<b>REFERENCE:</b>	<b>TSB:</b> 14-004-23 <b>GROUP</b> 14 - Fuel System	<b>Date:</b>	July 1, 2023	<b>REVISION:</b>	14-010-21
<b>VEHICLES AFFECTED:</b>	2021 – <b>**2023**</b> (JL) Jeep Wrangler <b>**This bulletin applies to vehicles built on or before March 15, 2023 (MDH 0523XX) equipped with a 2.0L I4 DOHC DI Turbo PHEV Engine (Sales Code ECX).**</b>			<b>MARKET APPLICABILITY:</b> <input checked="" type="checkbox"/> NA <input checked="" type="checkbox"/> MEA <input type="checkbox"/> SA <input checked="" type="checkbox"/> IAP <input checked="" type="checkbox"/> EE <input type="checkbox"/> CH	
<b>CUSTOMER SYMPTOM:</b>	<p>Customers may experience a Malfunction Indicator Lamp (MIL) illumination. Upon further investigation the technician may find that one or more of the following Diagnostic Trouble Codes (DTCs) have been set:</p> <ul style="list-style-type: none"> <li>• P04EC - EVAP System Large Leak Detected - Fuel Tank Side.</li> <li>• P04EE - EVAP System Very Small Leak Detected - Fuel Tank Side.</li> </ul> <p>Customers may also comment the following:</p> <ul style="list-style-type: none"> <li>• There is a "Check Gas Cap" message in the Instrument Panel Cluster (IPC).</li> </ul> <p><b>

**Fig. 1**  
**Fuel Filler Cap Fastener And Tether**

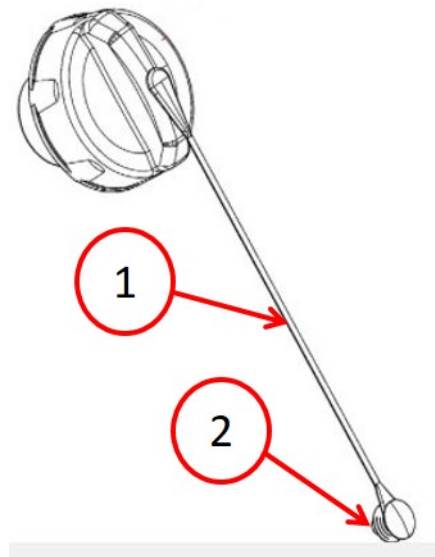
<b>CAUSE:</b>	There is an air leak through the fuel filler cap to fuel filler neck seal because the fuel filler cap tether gets caught between them.

3. Remove the fuel filler cap (Fig. 1) from the filler tube.
4. \*\*Cut the existing tether near the base that is mounted in the back of housing and discard cap/tether (Fig. 1) .
5. Replace the tappet base on the fuel door with the new part.

6. Install tether onto the new mounting provision on the new tappet base.\*\*
7. Install the new fuel filler cap tether (Fig. 1) on the fuel filler cap.
8. Install the fuel filler cap (Fig. 1) on the filler tube.
9. Close the fuel filler door and verify there is no binding with the tether.
10. Clear any DTCs that may have been set.
